<b>MATERIAL</b>		Chinese steel 45	
<b>FINISH</b>		Remove all sharp edges/surfaces and sharp break of edges 0.27-0.254mm ZINC PLATING WITH PART MICRONS MINIMUM PLATING THICKNESS AND TRivalent Chromium PASSIVATION AND WITHstand 96 HRS TO WHITE / 144 HS TO RED RUST IN SALT SPRAY TEST.	
<b>Zhejiang Geocheng Autoparts Co., Ltd</b>			
<b>PART NO</b>		5502-8 LT	
<b>SCALE:</b>		<b>APPD:</b>	
NTS		批准	
<b>DATE:</b>		<b>日期:</b>	
NTS		2020.01.07	
<b>CHK:</b>		<b>审核:</b>	
NTS		Li Jumbiao	
<b>DATE:</b>		<b>日期:</b>	
NTS		2020.01.07

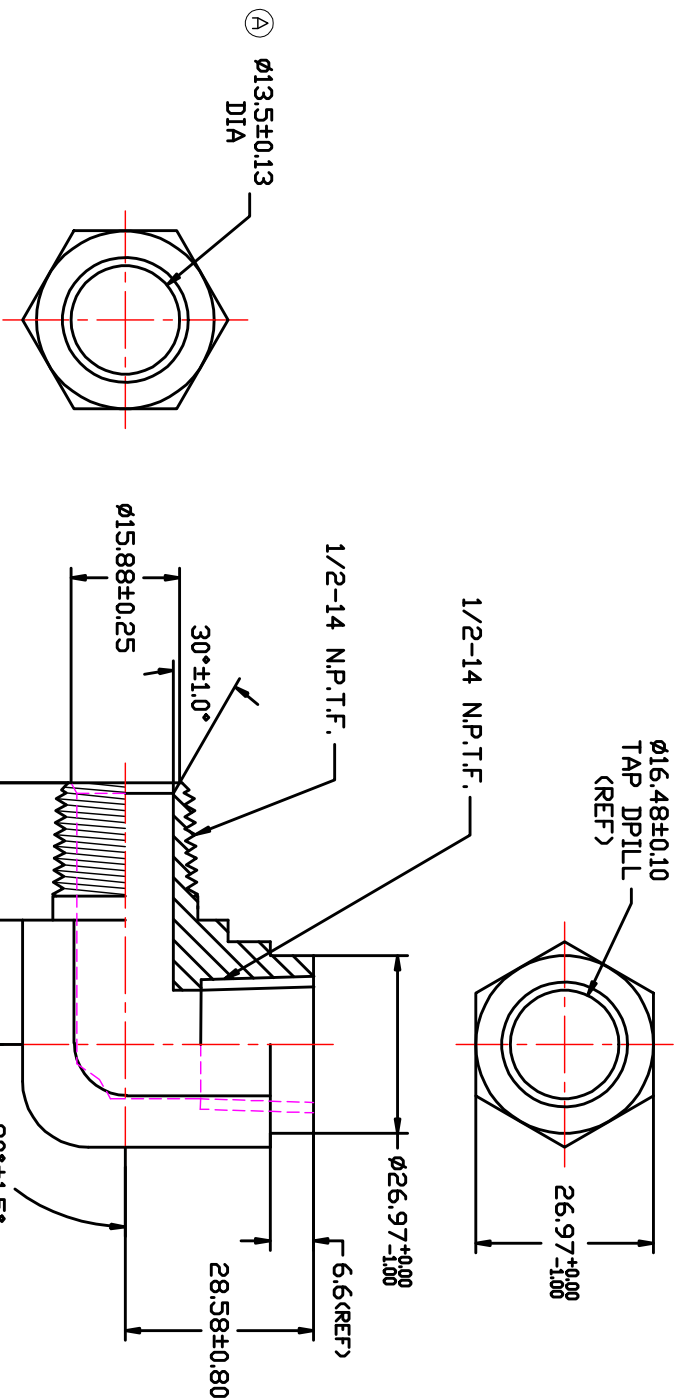
REV	DATE	REVISION DETAILS	APPD
序号	日期	变更内容	审核/批准
Ⓐ	2015.03.07	Ø12.95±0.13 改为 Ø13.5±0.13 Change Ø12.95±0.13 to Ø13.5±0.13	
Ⓑ	2020.01.07	Drawing Update
